Issuance Date: 2/25/2020 Effective Date: _____
 Owner: Town of Whitestown, Indiana Owner's Contract No.: _____
 Contractor: Atlas Excavating, Inc. Contractor's Project No.: _____
 Engineer: ms consultants, inc. Engineer's Project No.: 61-04D27-01
 Project: Legacy Core Lift Regional Station Expansion & 24" Trunk Line Contract Name: _____

CHANGE ORDER NO. 02 SUMMARY

**TOWN OF WHITESTOWN, IN
LEGACY CORE REGIONAL LIFT STATION EXPANSION & 24" TRUNK LINE
ENGINEER'S PROJECT NO. 61-04D27-01**

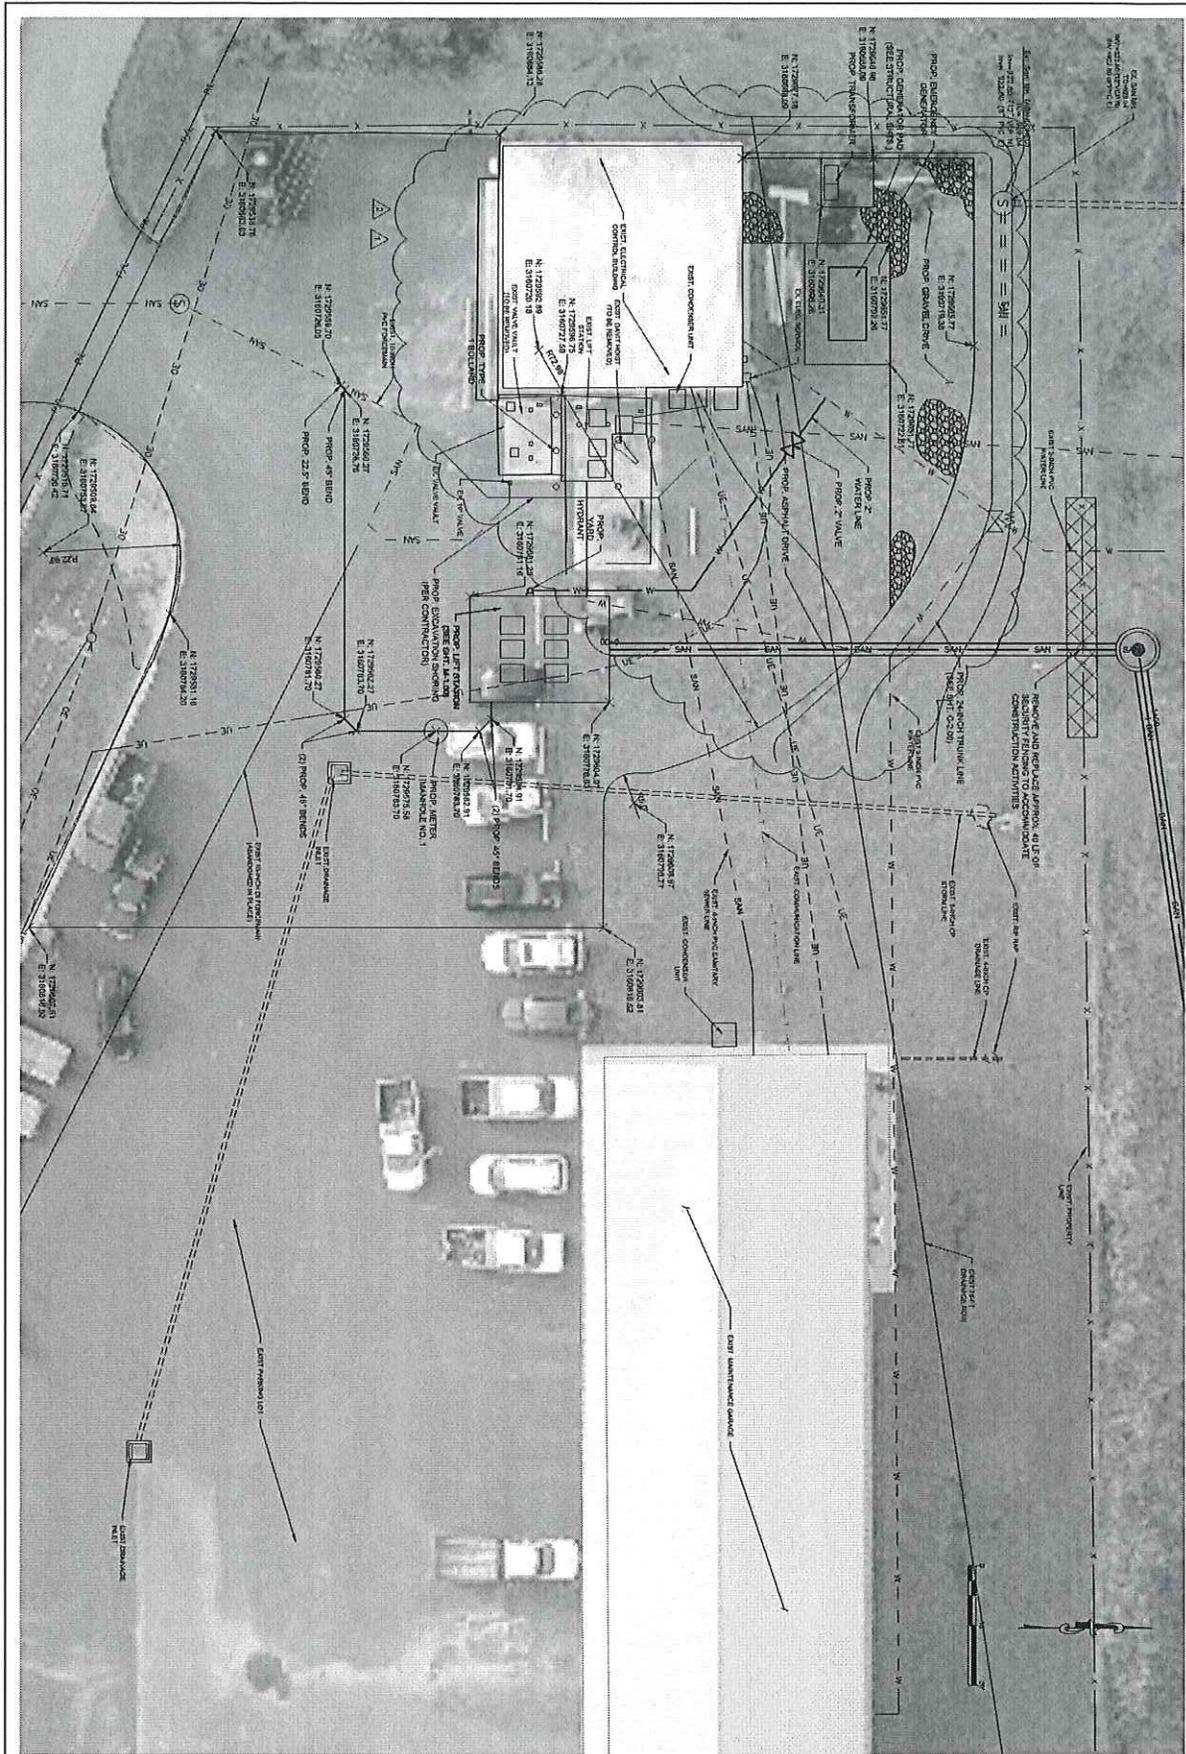
Summary of Change: The change to the above referenced sheet shows replacing asphalt around the Duke Energy transformer to gravel.

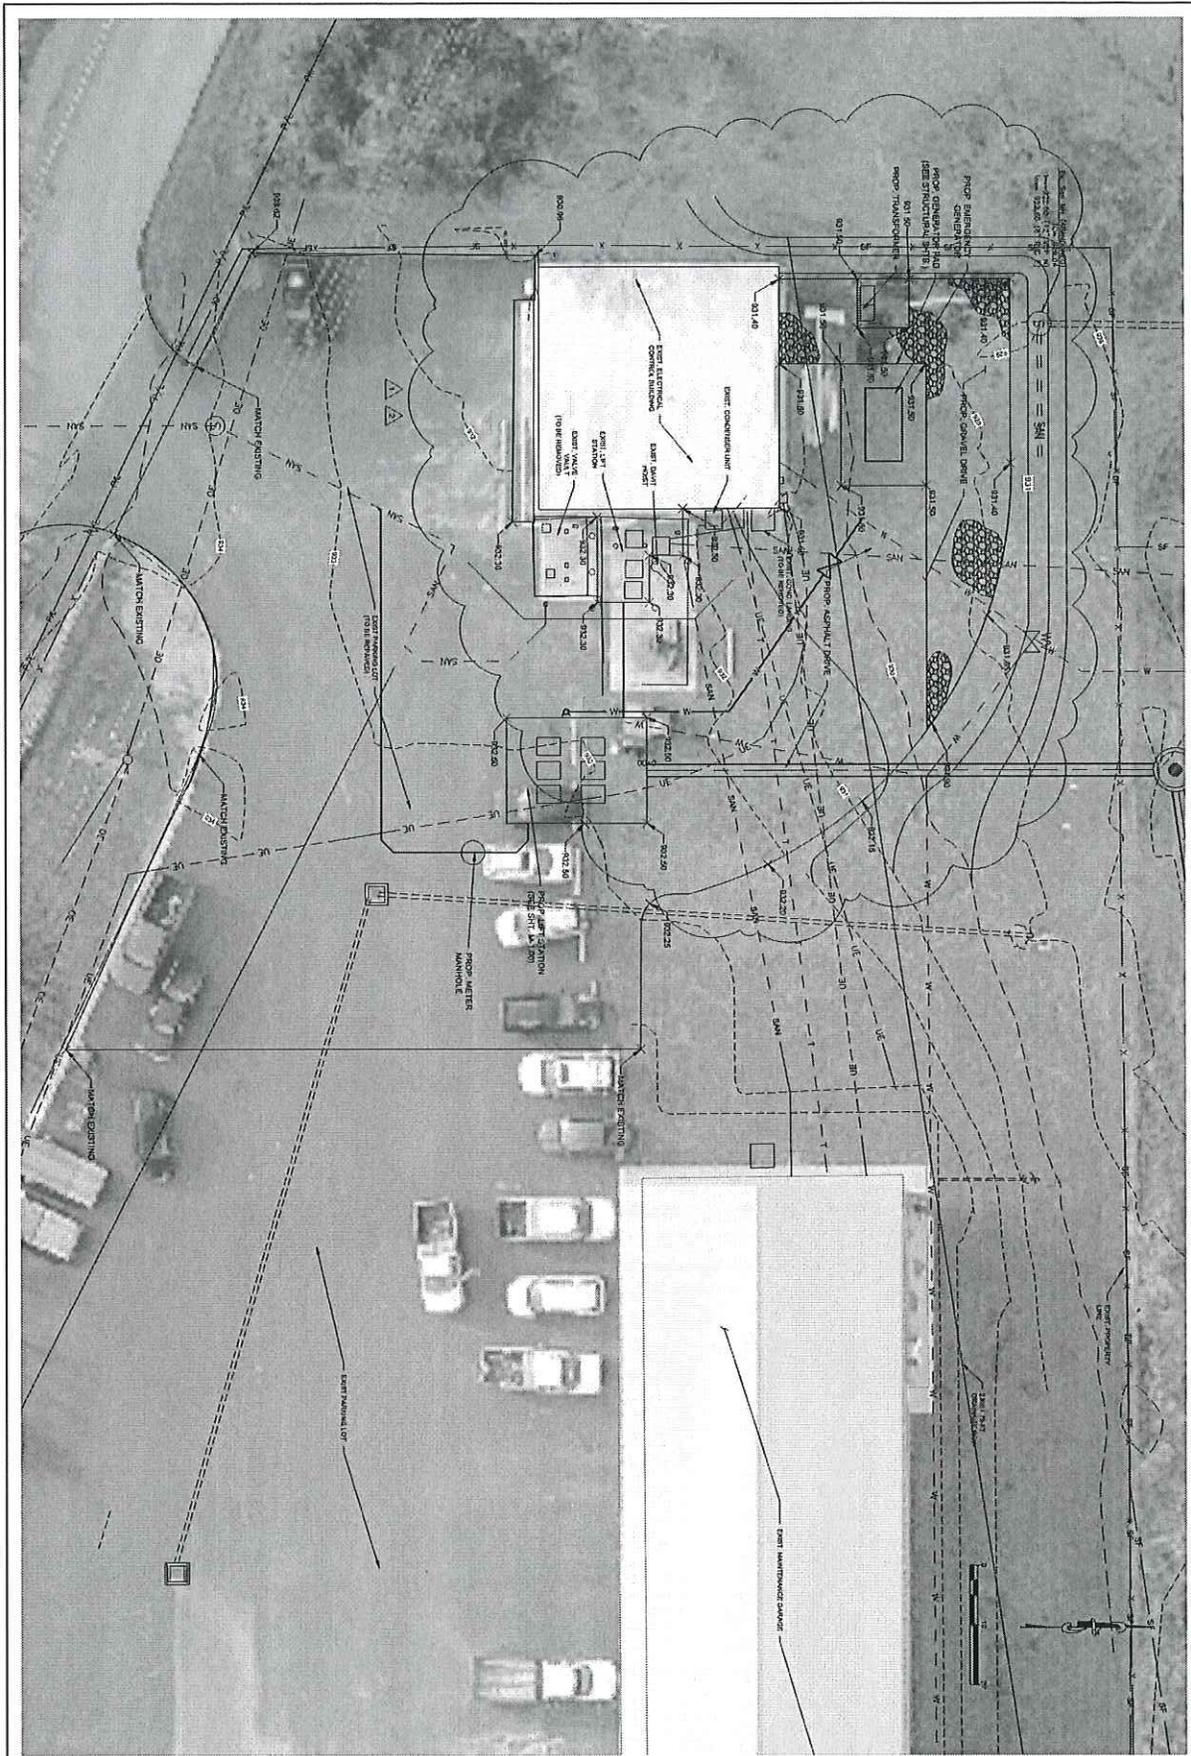
Summary of Change: The change to the above referenced sheet shows replacing asphalt around the Duke Energy transformer to gravel.
